URGENT: MEDICAL DEVICE CORRECTION (NOTIFICATION)

This information concerns all lots for the following Impella heart pumps:

Impella® 2.5	Impella® 5.0	Impella® 5.5 with Smart Assist
Impella® LD	Impella® CP	Impella® CP with Smart Assist

This letter is to notify you about additional information that Abiomed, Inc (“Abiomed”) is providing for the continued safe use of Impella heart pumps in patients with a transcatheter aortic valve replacement (TAVR).

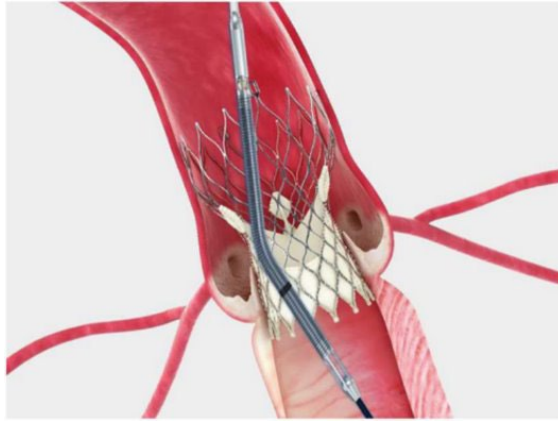
There is a potential risk for unintentional interaction of the Impella motor housing with the distal stent of a TAVR resulting in destruction of the impeller blades. This has resulted in low flow from the damaged Impella system.

The outflow struts of the TAVR can enter the outlet opening of Impella and damage the impeller (see figure below) during repositioning of the Impella while the impeller is spinning. This interaction while the impeller is spinning can result in fracture of the impeller material. Although no events have been identified, systemic embolization of the fractured impeller material is a possibility.

This risk of interaction is increased for oversized or under expanded frames with the distal ends not flush with the aortic wall, resulting in the distal stent structures oriented in such a way as to potentially enter the outflow window and allow contact of the end of the stent with the spinning impeller.

Clinicians are cautioned to position the Impella system carefully in patients with TAVR, and to be aware of this potential interaction. In this situation, clinicians should avoid repositioning while the device is spinning and should turn the device to P0 during repositioning or any movement that could bring the outlet windows into proximity to the valve stent structures.

If there is low flow observed in a patient implanted with a TAVR while on Impella heart pump support, you should consider damage of the impeller and replace the Impella pump as soon as possible.
